**PUC**

**COMMENTS AND RESPONSES  
ON JULY-AUGUST, 2008 PUC BALLOT  
PROPOSALS**

(Reviewed and balloted at PUC meetings  
September 9 and December 9, 2008)

**“D1.2.2 Column Limitations**

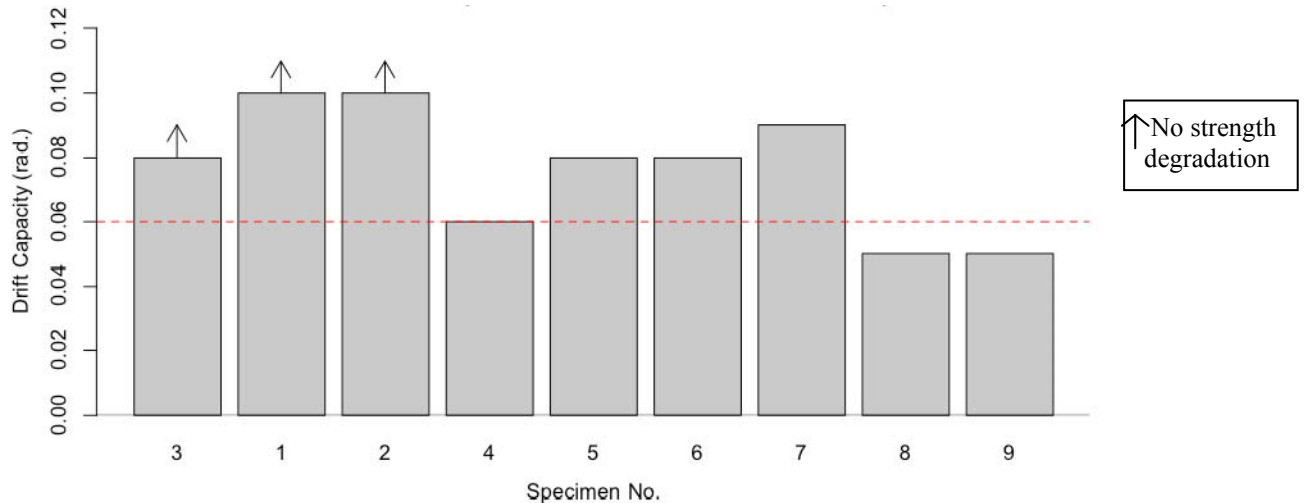
The size of square HSS (HSS 8 to 12) used in archetype design extend somewhat beyond the test database (HSS 8 to 10); a deeper HSS section is sometimes used to increase the lateral stiffness of the frame. The following modification is made to Section D1.2.2:

*In addition to the requirements of D1.2.3, columns in CFS-SBMF systems shall be ASTM A500 Grade B cold-formed steel hollow structural section (HSS) members painted with a standard industrial finished surface, and designed in accordance with Chapter C of AISI S100. The column depth shall be not less than 8 in (203 mm) or greater than 12 in (305 mm). The flat depth-to-thickness ratio shall not exceed  $1.58\sqrt{E/F_y}$ .*

**Figure 11.4- 1 Design Response Spectrum**

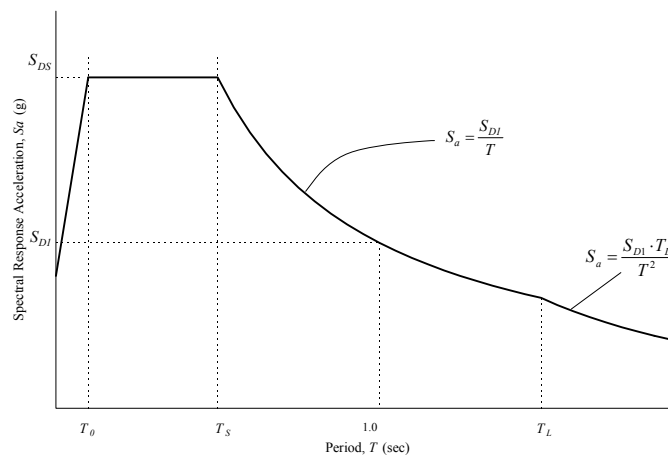
**Hamburger (YR):** On page 6, line 17, It appears that reference to Figure 22-7 should be to Figure 11.4-1. In Section 21.2.1.2 – there is a typo: (line 39 – functions should be function). In the same Section 21.2.1.2 I find the terminology “derivative of the collapse fragility” to be confusing. I recommend deleting the words “derivative of” and saying simply: “iterative integration of a site-specific hazard curve with a lognormal probability density functions representing the ~~derivative of the~~ collapse fragility (i.e., probability of collapse as a function of spectral response acceleration.”

*Page 6, Line 17. Non-Persuasive edit. Figure 22-7 is the correct reference.*
